STAFF MEMORANDUM  
Zoning Administration  
January 8, 2019  
**Item #1**

**File: 11203-18G-18DR**  
**Grading Approval and Design Review Approval for a new single-family residence**  
**Address: 15487 Bohlman Road, Saratoga, CA**

**PROPOSED EXTERIOR ELEVATIONS**

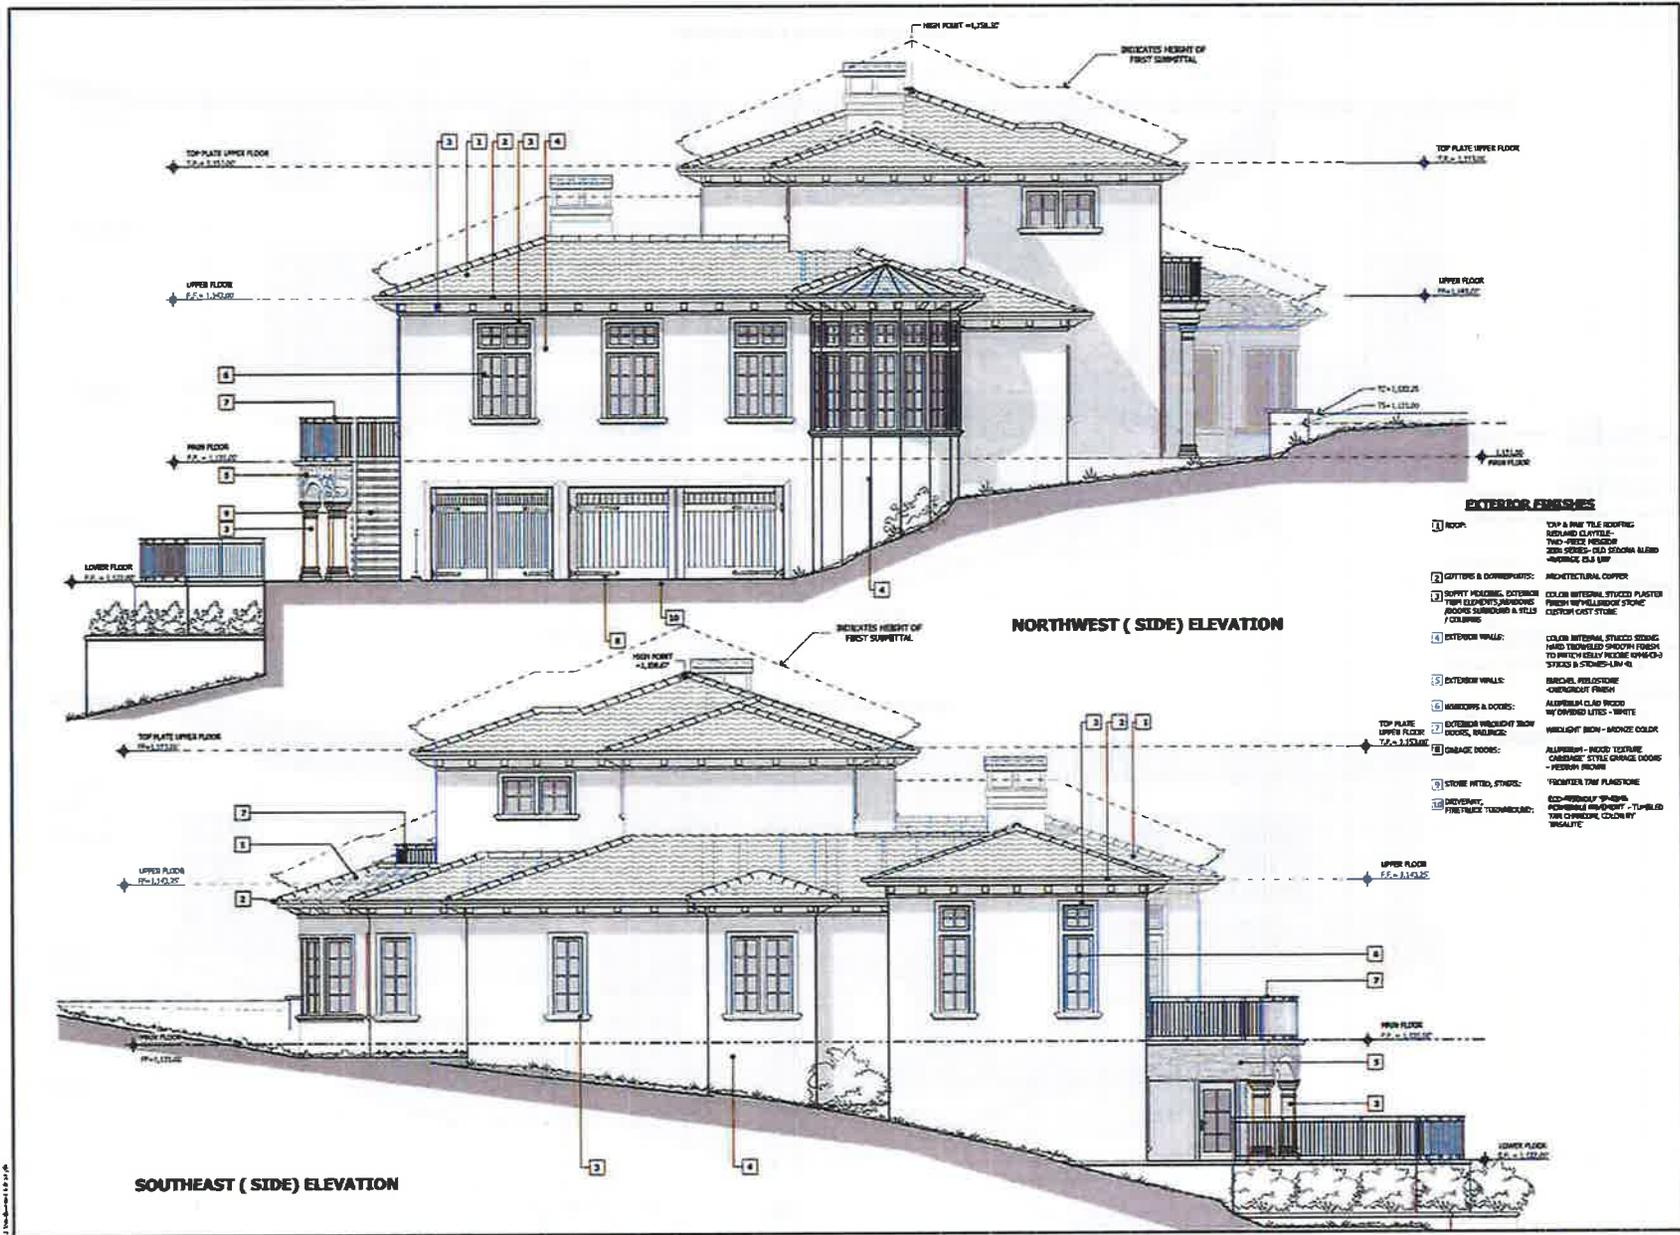
The area of the proposed residence that could create privacy impacts toward the neighboring property to the east include large windows, with short window sills, as seen on page A-3.1 of the project plans. In keeping with the County Design Review Guidelines, and to mitigate privacy impacts, staff has included a condition of approval requiring that any non-egress windows facing the property to the east are designed to be clerestory windows, with five-foot tall window sill. This will limit the applicants views to the neighboring property. Staff has discussed this with the Applicant, who has agreed to this solution.
